REMARKS

Claims 16-21 are added so that claims 1-21 are now pending in the patent application. Dependent claims 10-12 are indicated to be allowable and re-written in independent form in claims 20-22.

FIG. 10

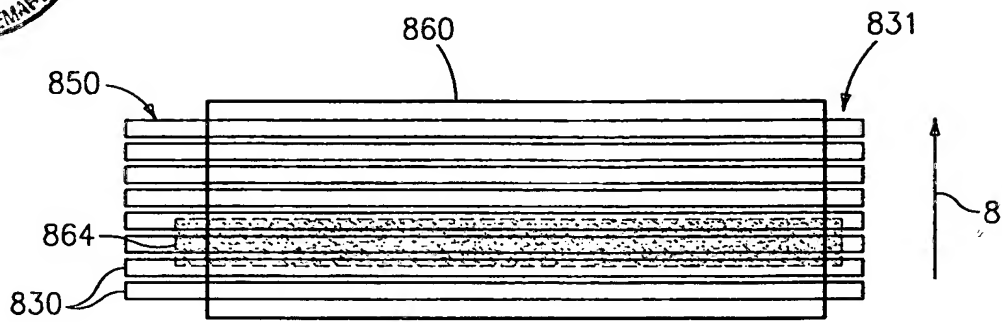
In paragraphs 3-10 of the Office Action, the drawing are objected to for various informalities.

The drawing and/or the specification have been amended in view of the points raised in paragraphs 3-10. Enclosed are amendments to Figures 10, 15, 27 and 52(a) with red ink markings and associated replacement pages marked accordingly.
